SAFETY BULLETIN FROM WINDCREST (UK) LTD

Please find enclosed Safety Bulletin from Windcrest (UK) Limited regarding a modification to the interconnection between the Windcrest 'Liftalert' system and the lift controller.

Safety Note: LiftAlert Interconnection to the Lift Controller

Solution 2. Place a Resistor in the Safety line signal.

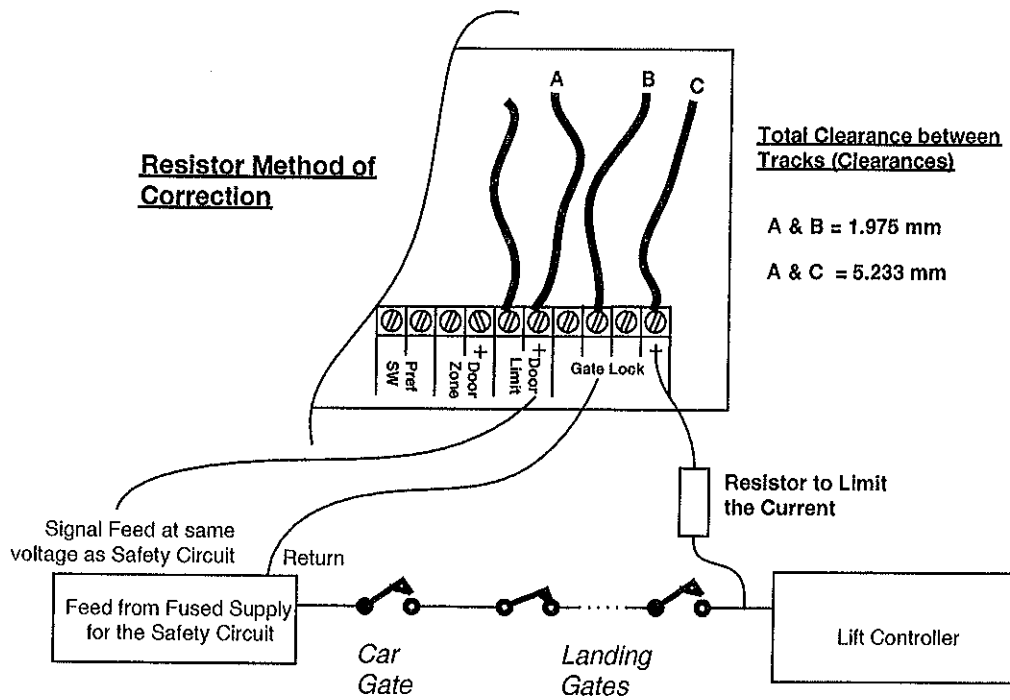
By placing a resistor in line with the safety line signal, the current will be limited, even if a track bridging takes place on the Interface Circuit. However, the current resistors, soldered on the board, will need to be replaced.

The installation of the LiftAlert's Interface board can be installed to meet a standard where the safety line's integrity is kept. However, to ensure the safety line is not compromised in any way, even if the wiring is inconsistent, solution 2 or 3 should be implemented.

Solution 3. Place a Relay to provide an isolated Safety line signal.

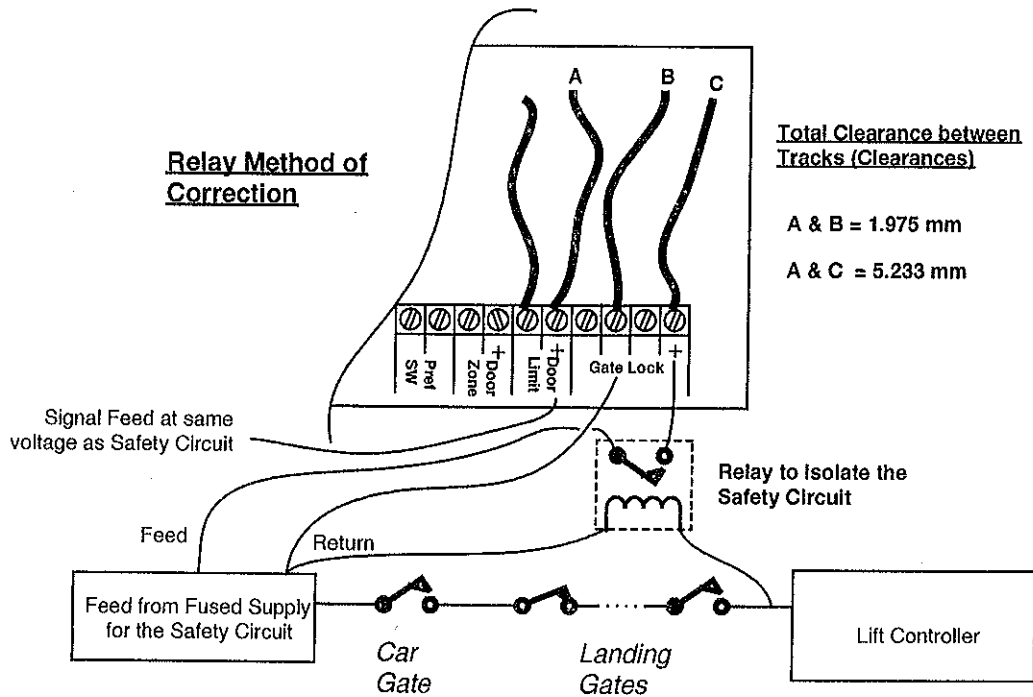
This method will provide good isolation and can be implemented without the change of resistors on the Interface board.
